**From:** Jim Pierce  
**Sent:** Wednesday, July 30, 2003 8:50 AM  
**To:** Lonnie Blaydes (E-mail)  
**Cc:** Mike Murphy; Steve Chutchian  
**Subject:** S.Quorum Railroad Crossing

Re: Railroad Crossing  
Landmark/S. Quorum

ROADWAY, DRAINAGE AND TRAFFIC SIGNAL DESIGN PLANS  
 INWOOD / SOUTH QUORUM ACCESS - PHASE II  
 INWOOD CONNECTION

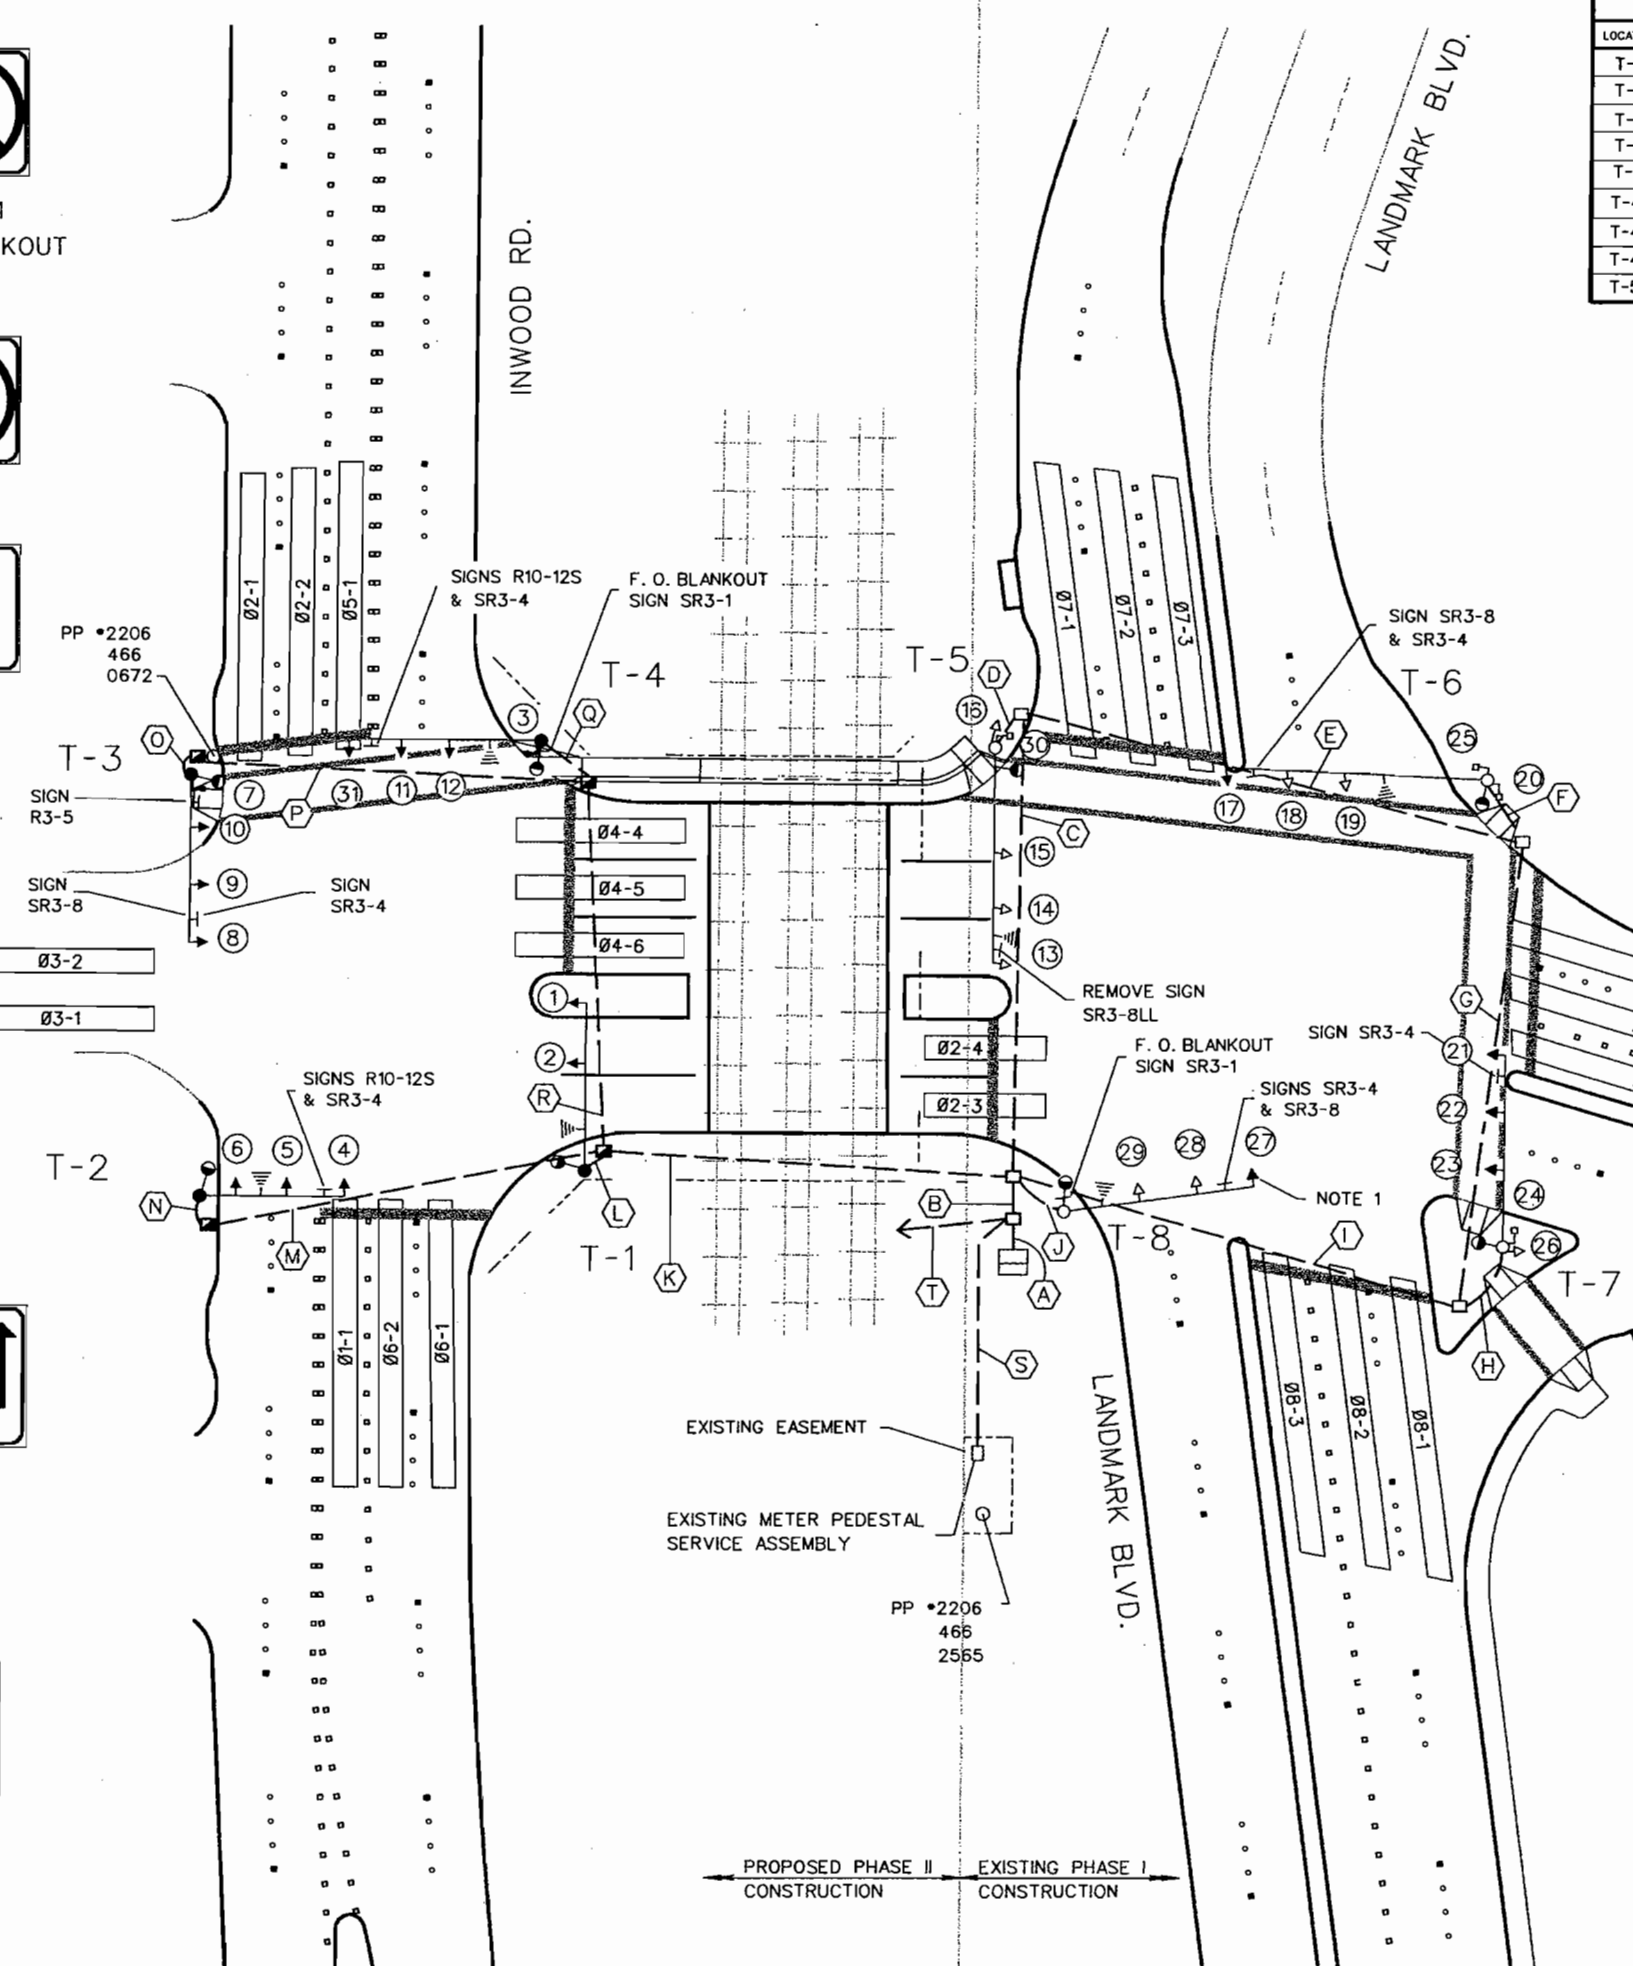
where are ped signal heads for phase II?  
not marked on this drawing.  
OTHERWISE, OK
